DRAWING AMENDMENTS

REMARKS

FIG 2
PRIOR ART

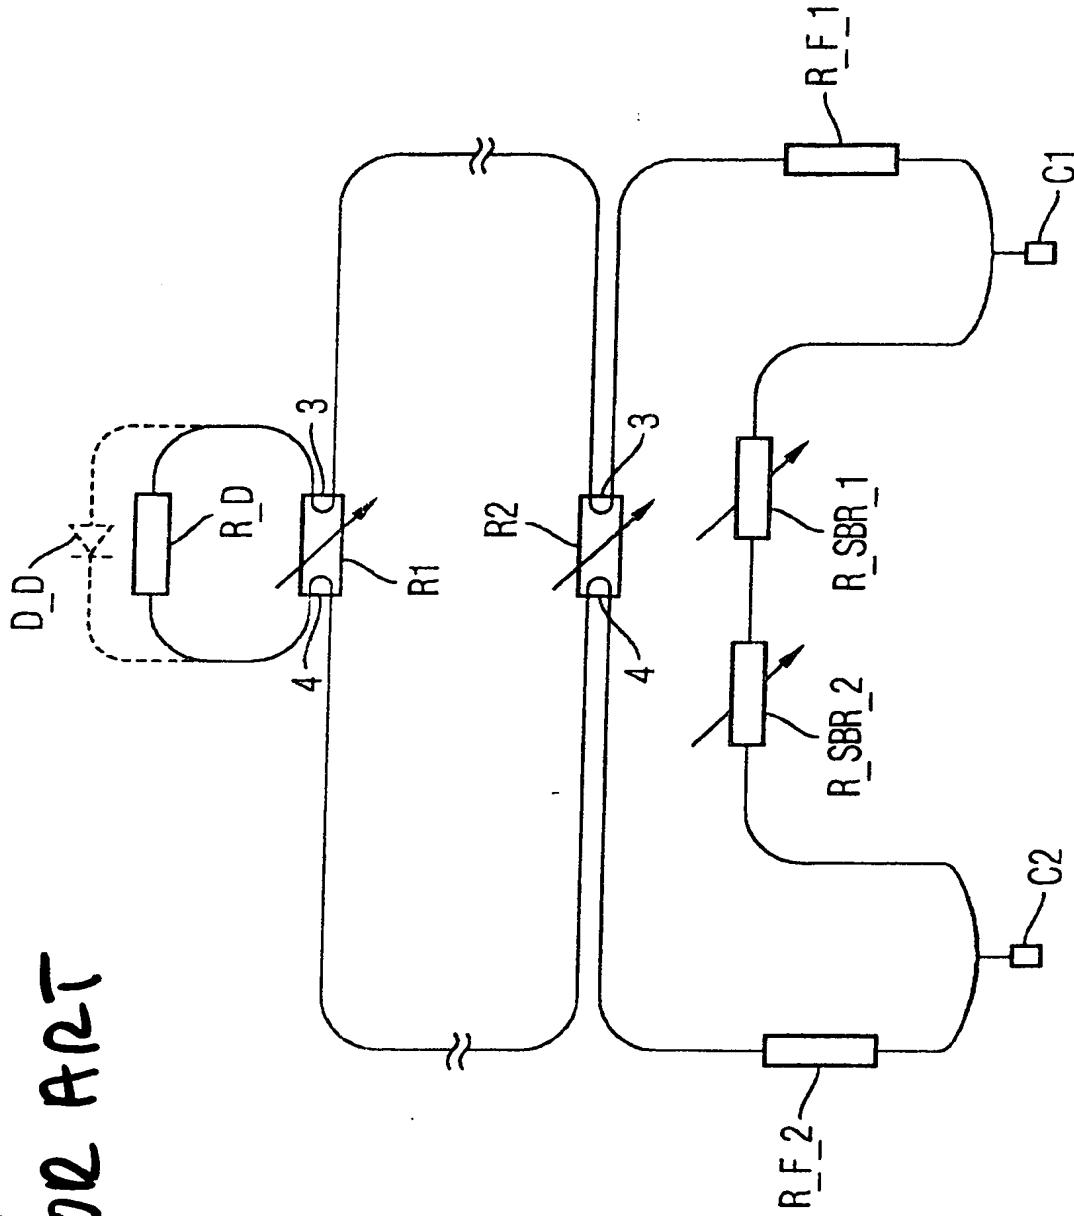
The attached sheet of drawings includes changes to Fig. 2. This sheet, which includes only Fig. 2, replaces the original sheet. Fig. 2 has been labeled as PRIOR ART.

Please approve the drawing changes that are marked in red on the accompanying "Annotated Sheet Showing Changes" of Fig. 2. A formal "Replacement Sheet" of amended Fig. 2 is also enclosed.

Under the heading "Drawings" on page 2 of the above-identified Office Action, the Examiner required corrected drawings to be filed. Fig. 2 has been labeled as prior art.

Under the heading "Claim Rejections – 35 USC § 102" on page 4 of the above-identified Office Action, claims 5-8 have been rejected as being fully anticipated by Fig. 2 (admitted prior art) under 35 U.S.C. § 102. Applicants respectfully traverse.

Claim 5 includes four measuring connections and three measuring circuits. Fig. 2 only shows two measuring connections and one measuring circuit.

In Fig. 2, reference numerals 3 and 4 identify electrical connections. Please refer to the translation at page 9, lines 10-15.

It appears that the Examiner has equated an electrical connection with a measuring connection. Applicants believe there is a clear distinction between a measuring connection and an electrical connection. Measuring connections, such as those defined by claim 5, are provided for measuring resistance values therebetween. In contrast, an electrical connection is merely provided to electrically connect one or more electronic components. Applicants believe it is clear that Fig. 2 shows only two measuring connections, namely C1 and C2. Additionally, since only two measuring connections are provided, only one measuring circuit could be formed.
